TPA CHANGE NOTICE FORM

TPA-CN- 679

PNNL-12220, "Sampling and Analysis Plan Update for Groundwater Monitoring 1100-EM-1 Operable Unit"

Figure 1. Location of 1100-EM-1 Line of Compliance and Monitoring Wells

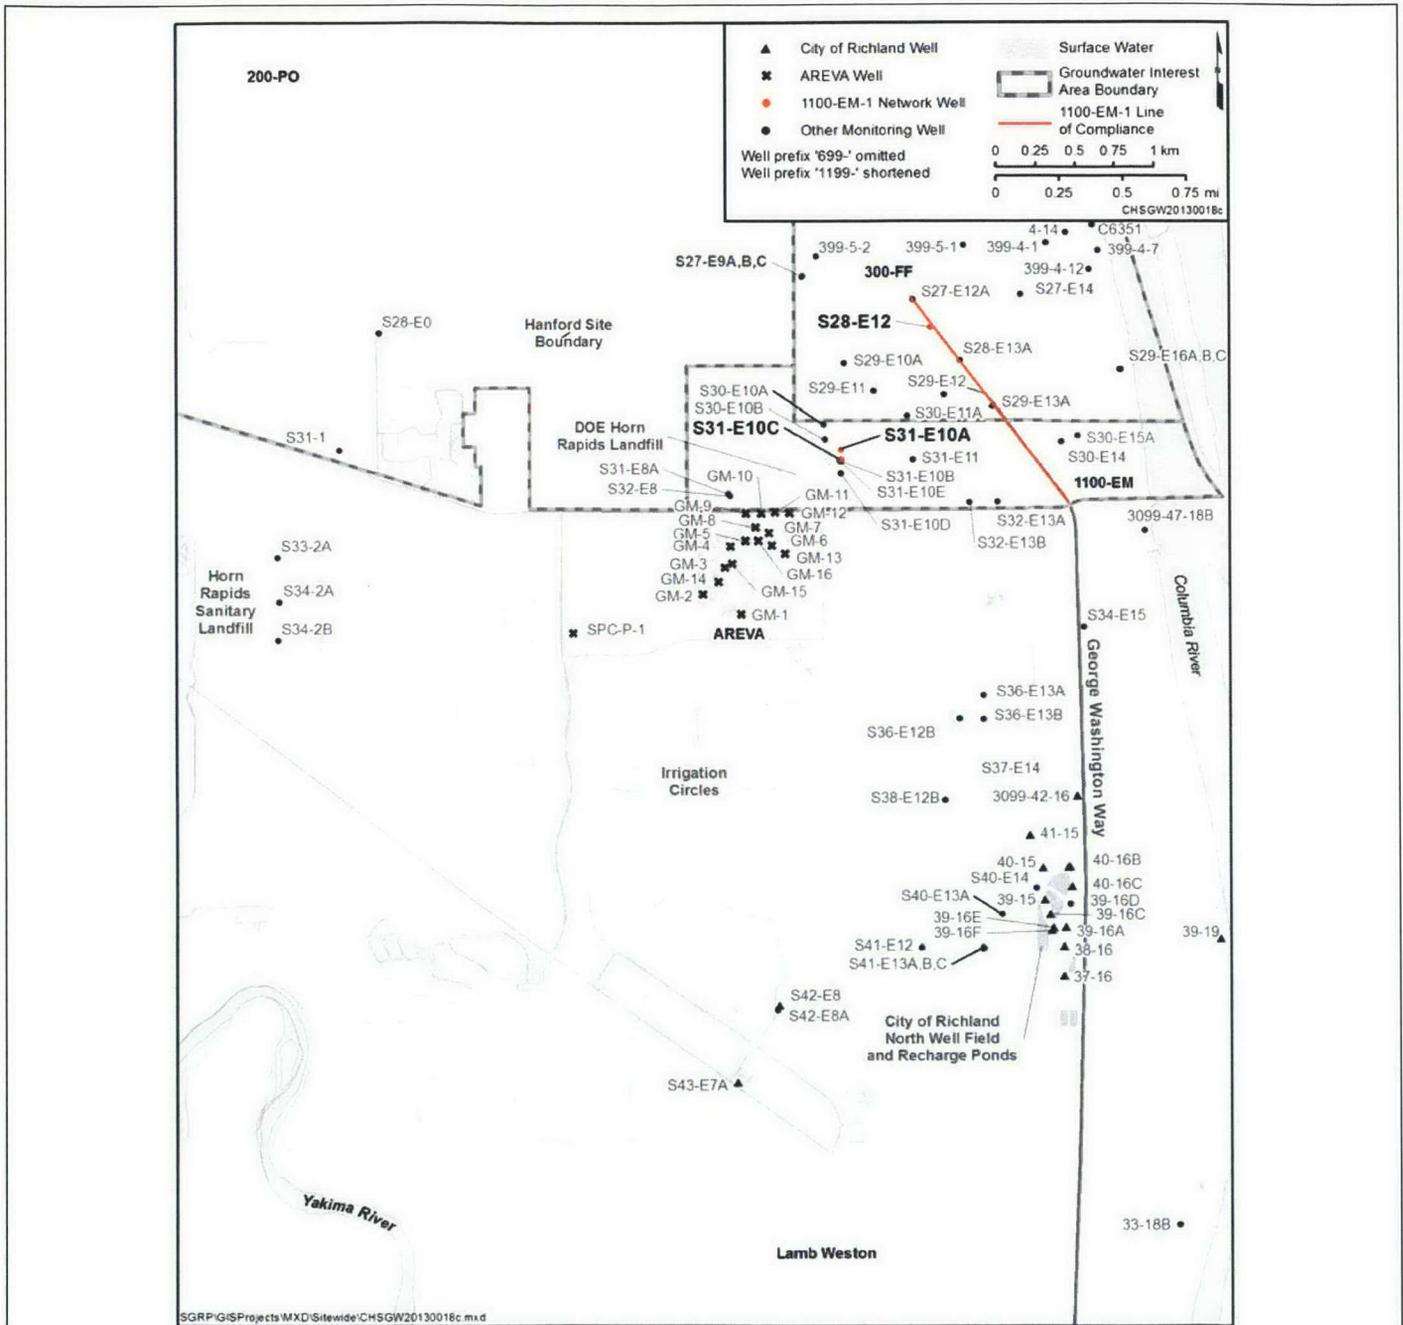
In 1993 EPA, Ecology, and DOE signed a ROD for the 1100 Area, including the 1100-EM-1 groundwater Operable Unit (EPA/ROD/R10-93/063). The ROD had a groundwater component that relied on MNA for trichloroethene (TCE), with a cleanup level of 5 µg/L at the designated point of compliance. The point of compliance was defined as the George Washington Way diagonal line (Figure 1).

Currently, monitoring of nitrate and uranium near the landfill, as well as tritium near the City of Richland's water supply wells, is described in DOE/RL-2012-59 (Surveillance Monitoring Plan). TCE is a contaminant of concern for 300-FF-5. The current monitoring requirements in DOE/RL-2012 include annual sampling for Wells 699-S28-E12, 699-S31-E10A, and 699-S31-E10C (Figure 1) for TCE, vinyl chloride, and 1, 2-dichloroethene.

Figure 2. Trichloroethene in 1100-EM-1 Compliance Wells (non-detects are plotted at the detection limit)

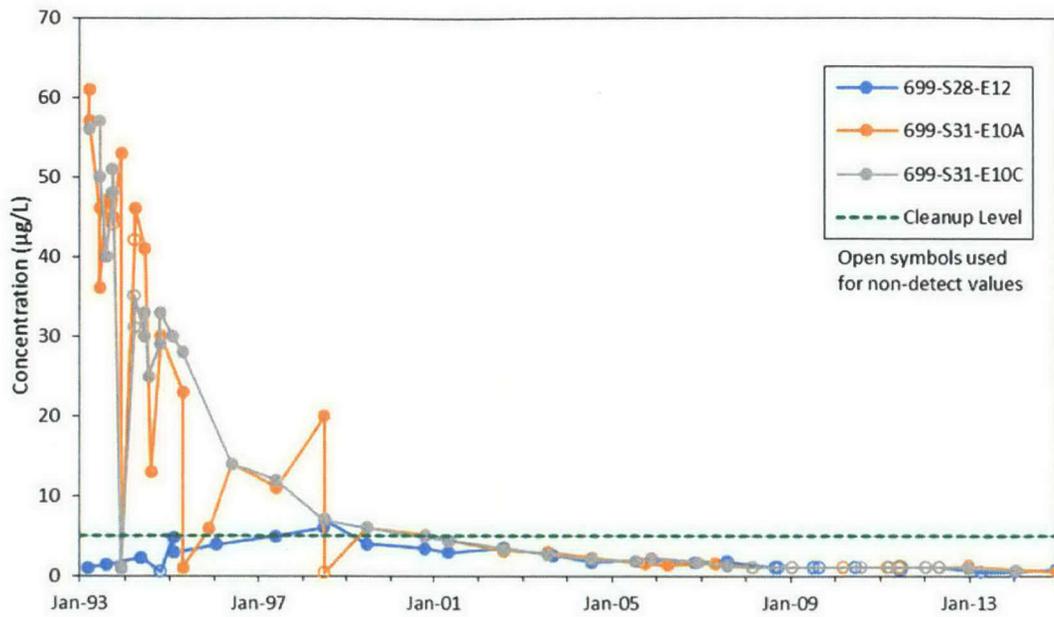
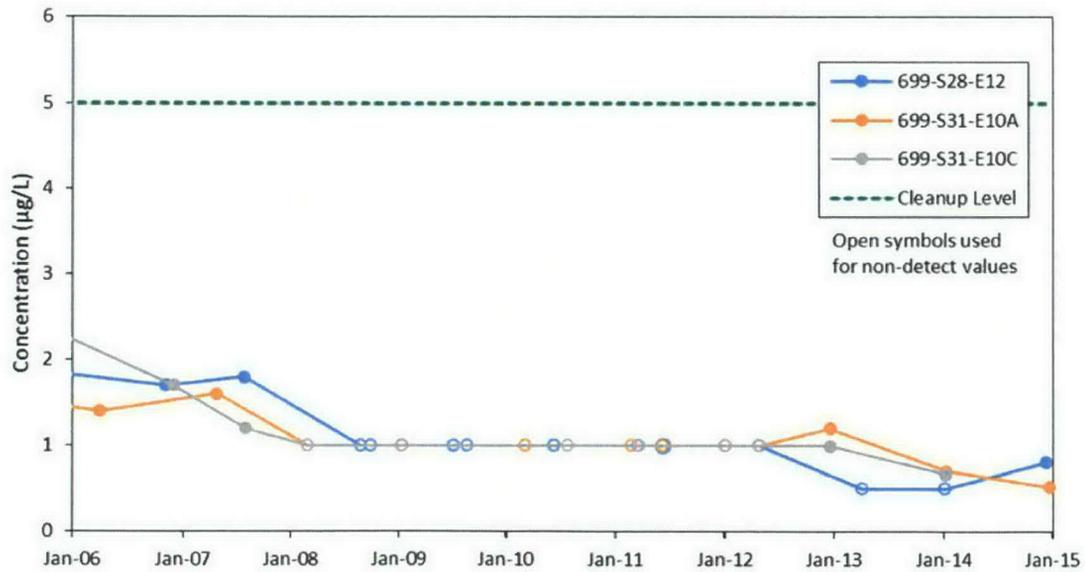
The upper panel of Figure 2 illustrates concentrations of TCE from 1993 through 2014. The lower panel shows detail for the period 2006 through 2014. Concentrations declined between 1993 and 2007, and have remained near or below 1 µg/L between 2008 and 2014.

TCE concentrations have met cleanup goals in all three 1100-EM-1 compliance wells since 2001. Data from thirteen years of subsequent sampling confirm that concentrations are stable at levels well below the cleanup goal. No further groundwater monitoring is needed for 1100-EM-1.
